12/12/18 - Added Tub Deck - 1st Floor Master (Platform Tub)

MODEL 2844

COVER SHEET

INVENTORY PROJECT
LOT 9 220 13 TH. AVE S.
SAFETY HARBOR, FL.

6A

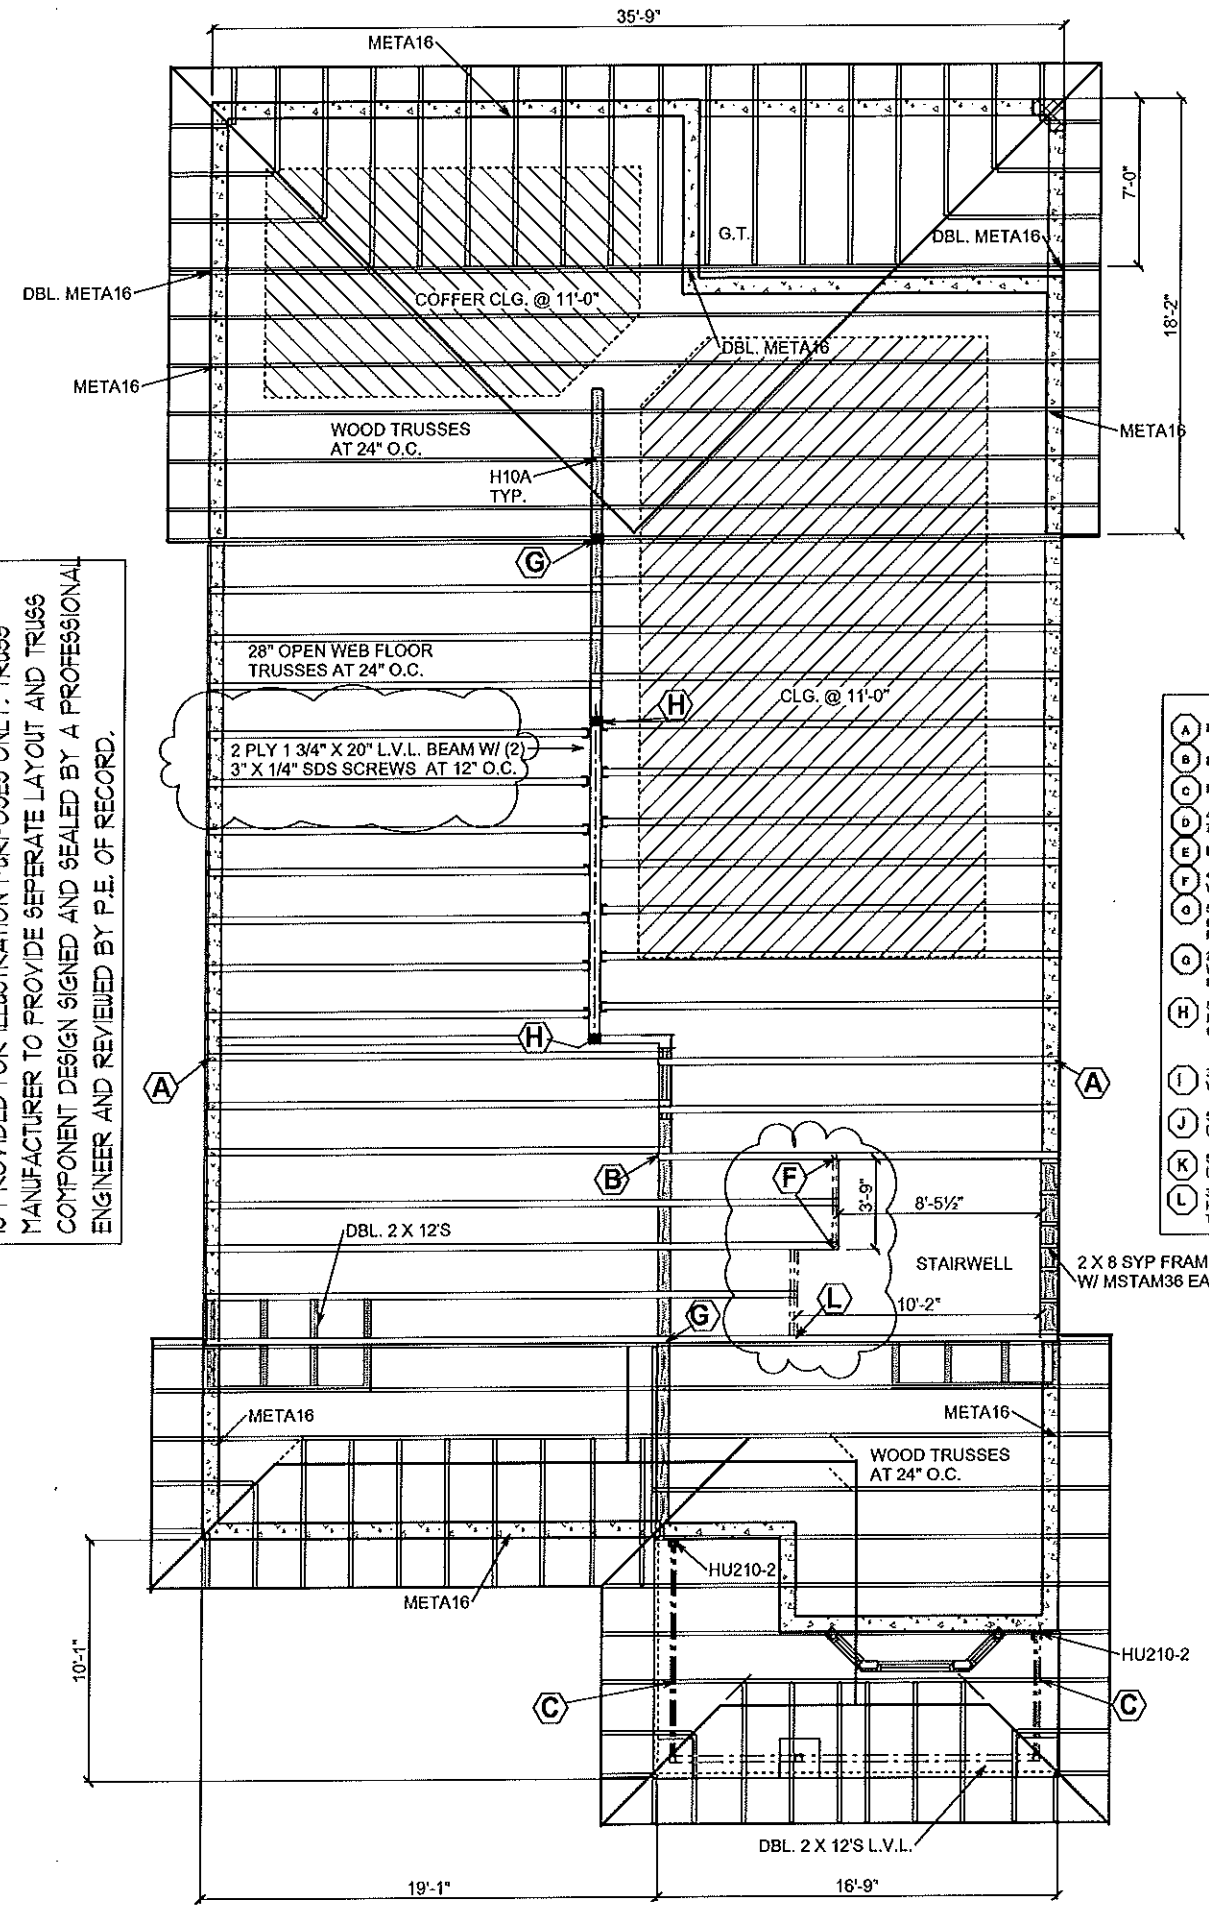
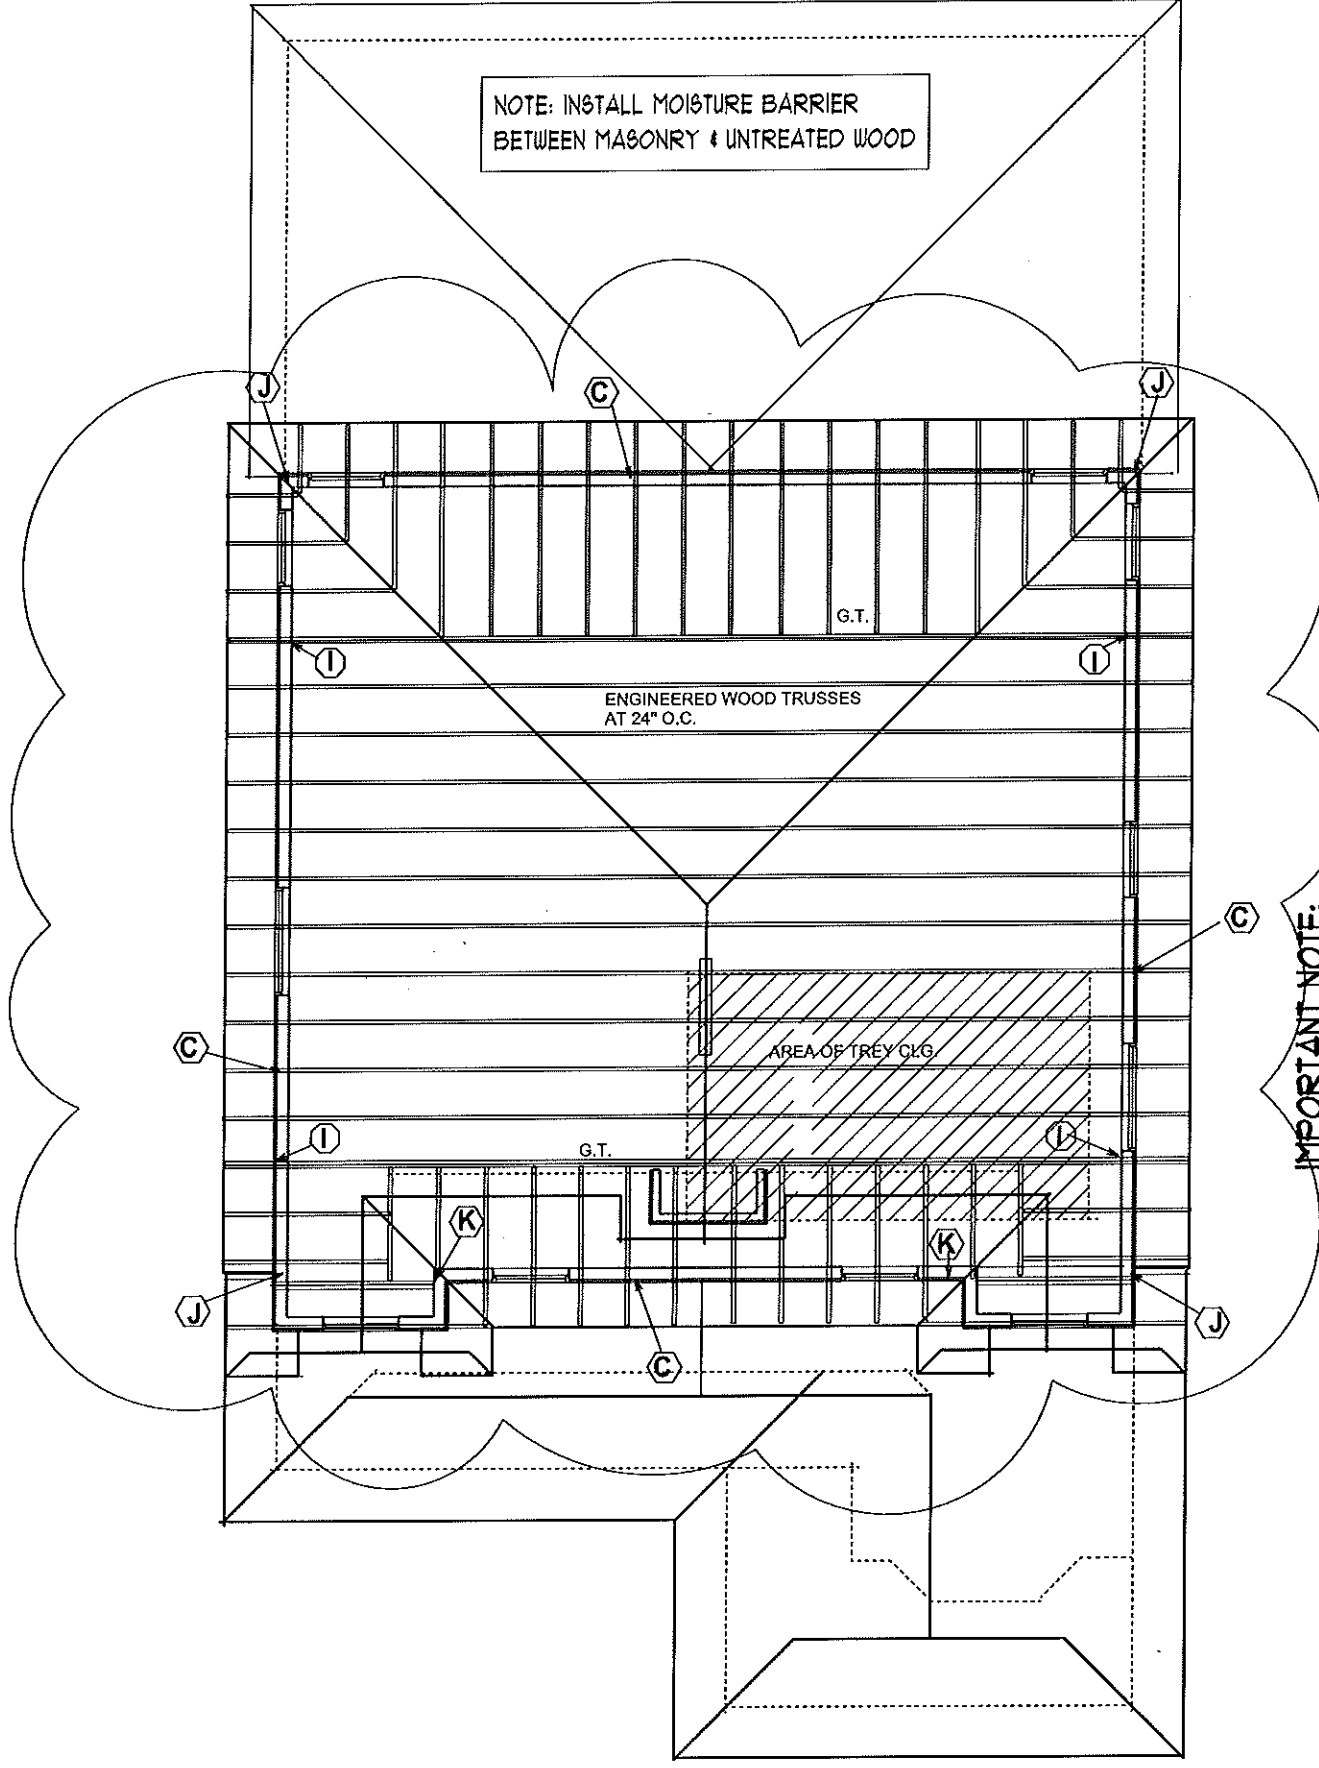
1/2/18 Corrected 6A - (LVL) 2011

12/28/18 - 6A Corrected to Match RUSPLAN posted 1/7/19

- A META24 TYPICAL
- B H3 TYPICAL
- C H16 TYPICAL
- D 4-PLY 20" VERSALAM W3 ROWS 7" SDS SCREWS @ 12" O/C
- E HUCQ412-SDS
- F 4X4 PT COLUMN W/ ABU44 W/2) NTS16 TO BEAM
- G 5-1/4" X 7" VERSALAM COLUMN W/2) CS16 @ EACH COLUMN TO BEAM W/2) HTTS TO FOUNDATION @ EACH COLUMN
- H 2X6 SYP @ 16" O/C W/SP2 TO TOP PLATE W/SP1 TO BOTTOM PLATE W/ 5/8" X 6" ARCHOR BOLTS W/3" SQ. WASHERS AT 24" O/C
- I 6.25 X 3.5 VERSALAM COLUMN W/ HTT4 TO FOUNDATION WITH (2) CS16 TO BEAM
- J 3 STUD COLUMN W/ LGT TO G.T. W/ (2) MSTAM36 TO CMU
- K 5 STUD CORNER COLUMN W/ (2) MSTAM36 TO CMU
- L 6 STUD CORNER COLUMN W/ (2) CS18 TO ORDER BELOW
- M 3.5 X 3.5 VERSALAM COLUMN W/ HTTS TO FOUNDATION W/ (2) CS16 TO ORDER
